Subject: 54/24/86/33 (Vol.1) - NZ Post Office - Cables - Tairua Harbour (1970-1979)

SUBMARINE CABLE - TAIRUA HARBOUR

Tairua Harbour: Proposed laying of
Submarine Cable

Tairua Harbour
Proposed Submarine Cable

TAIRUA : PROPOSED CABLE
ACROSS HARBOUR.

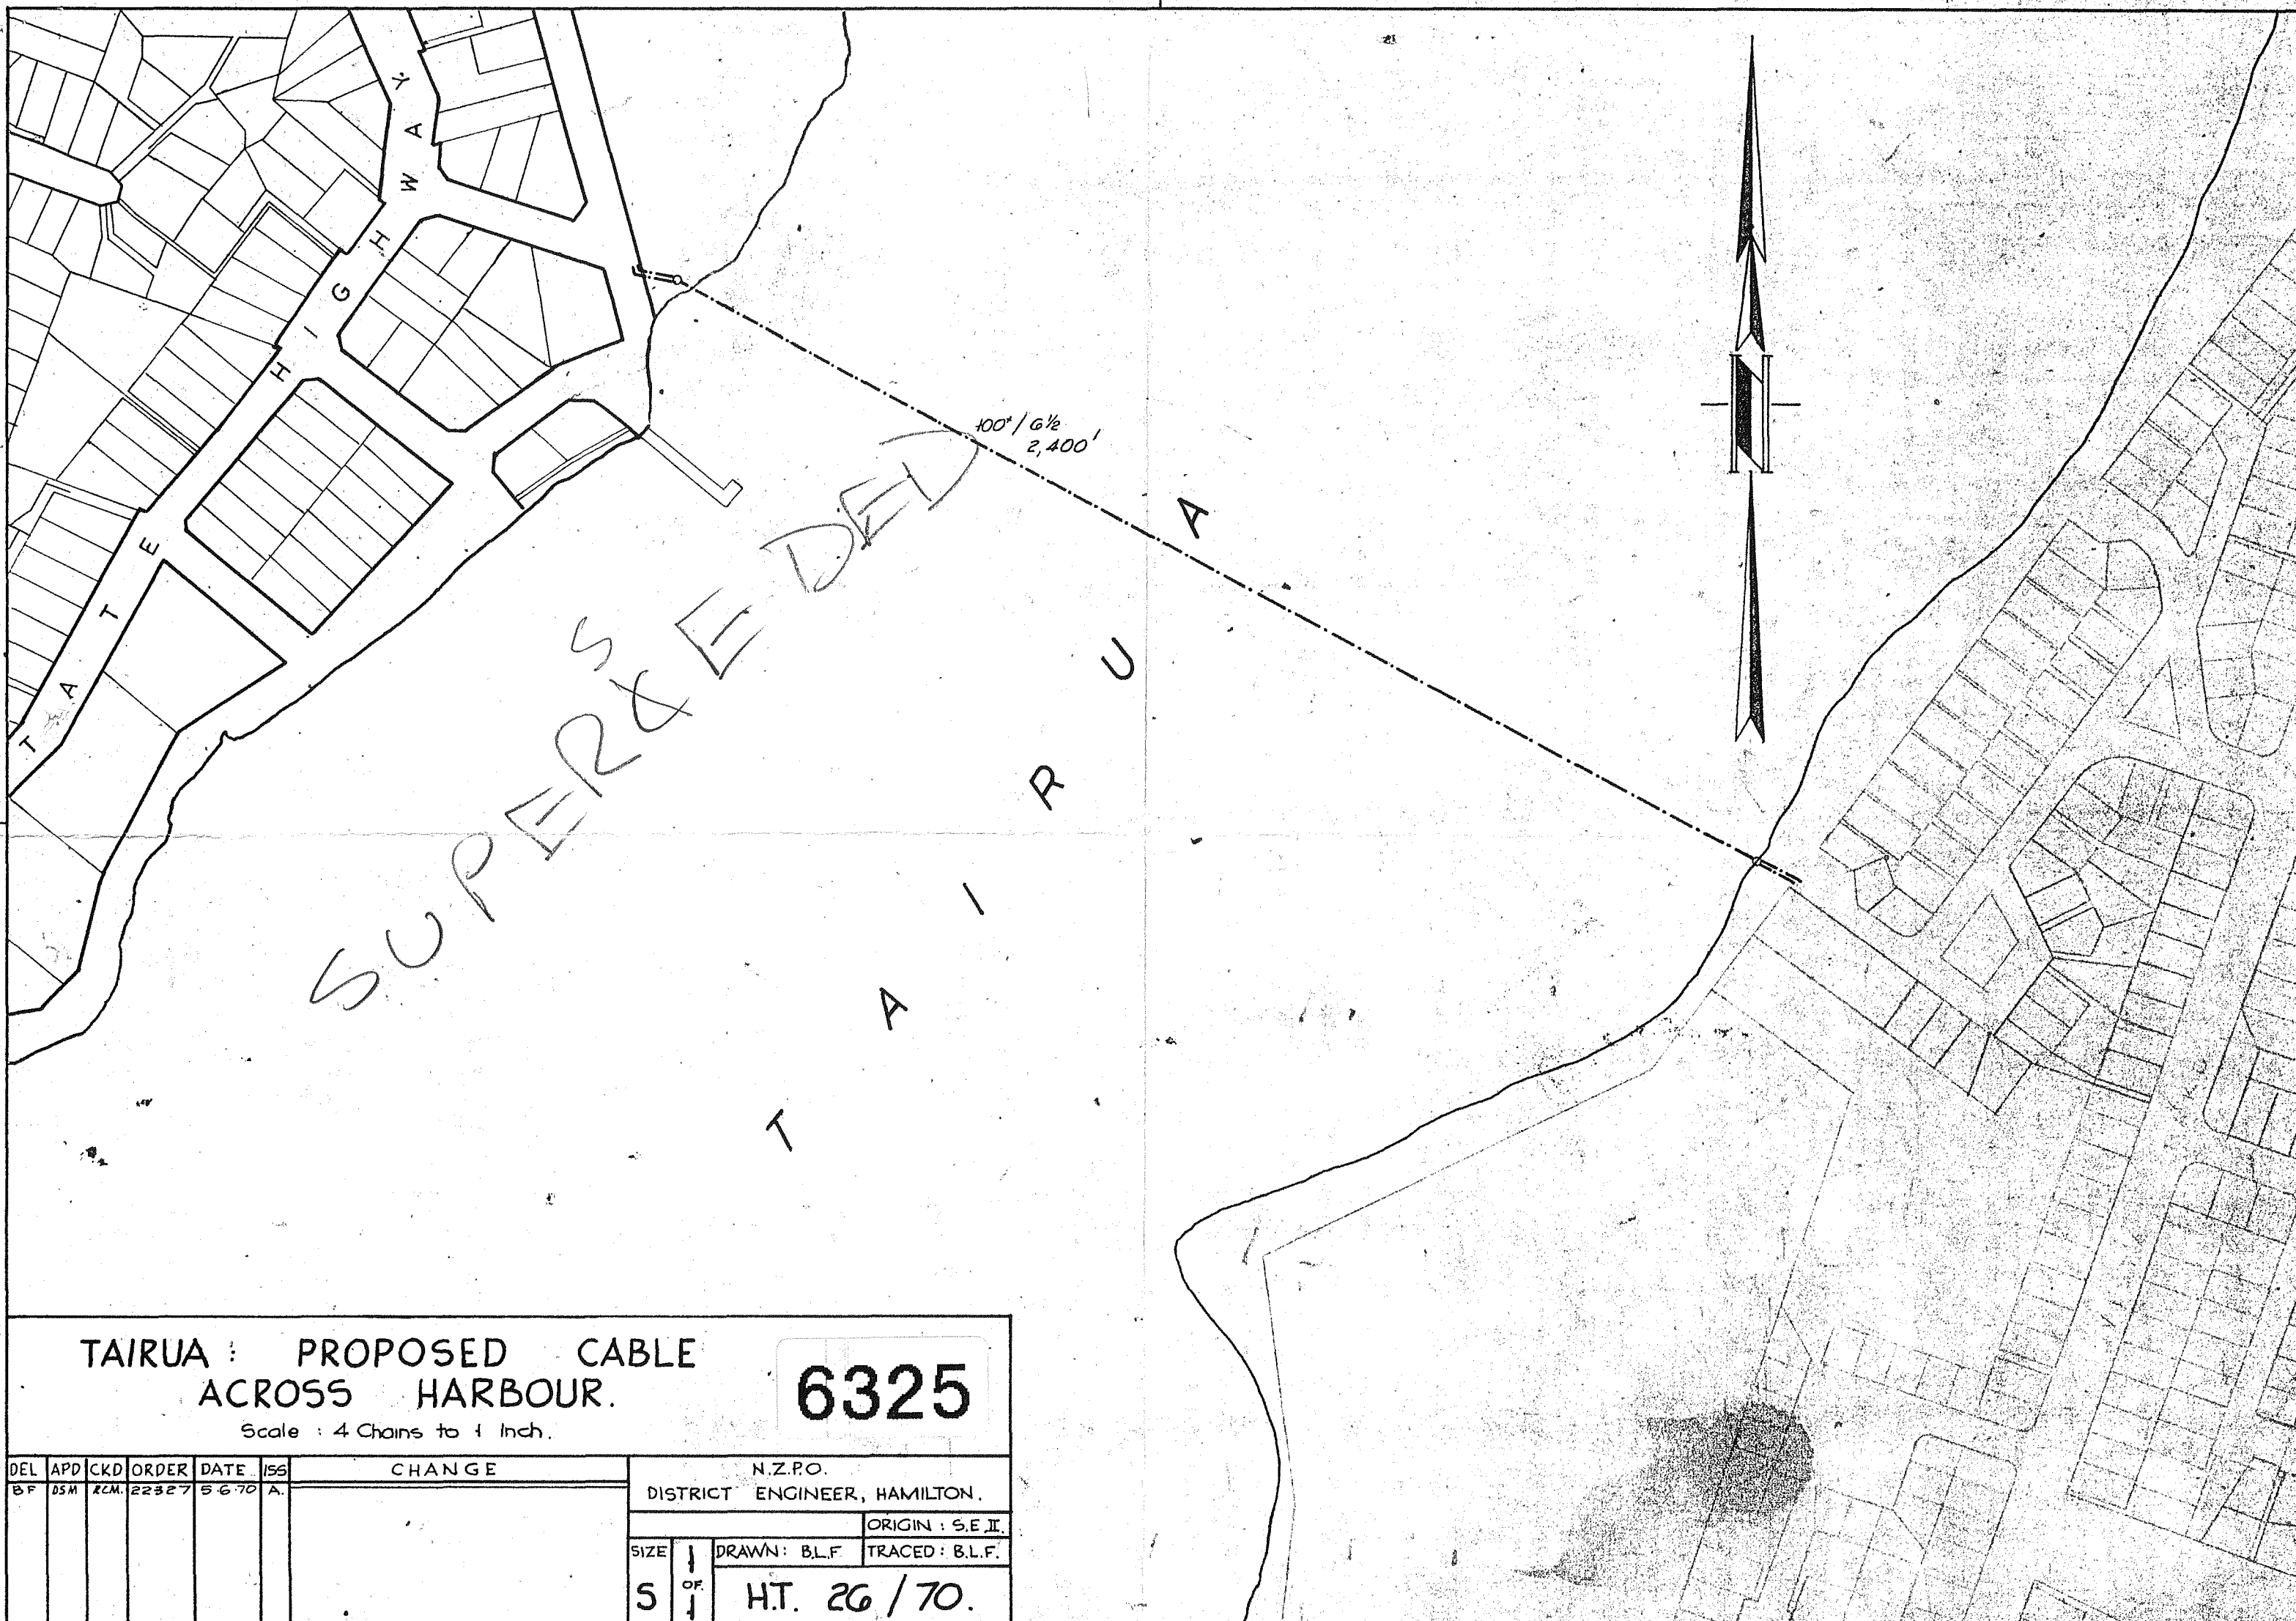
The steady silting in the Tairua Harbour over recent years is causing some concern and the Thames County Council are considering proposals for periodical deepening of the channel between the harbour entrance and the wharf. Cables in this part of the harbour should be buried clear of dredging operations.

The channel for eight to ten chains above the wharf is the normal anchorage for local launches and visiting craft. Cables in this area should be clear of anchor or mooring drag. The existing cable, marked in pencil on the plan, is bedded in the shallows clear of the anchorage.

Following discussion with you and an on site inspection it is agreed that the route of the submarine cable shall be substantially that suggested by you. Minor alterations have been made to the route to avoid the rock reef which was exposed at low water.

Further to your E.HN 17/358 I wish to acknowledge receipt of the plan mentioned therein and have to advise that in my opinion it would be better if you could arrange to instal the cable approximately on the lines shown in red on the enclosed plan.

Further to my telegram of 12 November 1970 this is to confirm that on 12 November 1970 your plan HT26/70, now marked M.D. 13991, showing a submarine telephone cable to be laid across the Tairua Harbour, was approved pursuant to section 178(b) of the Harbours Act 1950 subject to certain conditions. These are:-

1. That the cable has a minimum buried depth of 18" on the harbour bed, with a minimum buried depth of 36" through the main channel.
2. That standard submarine cable marker beacons are erected.
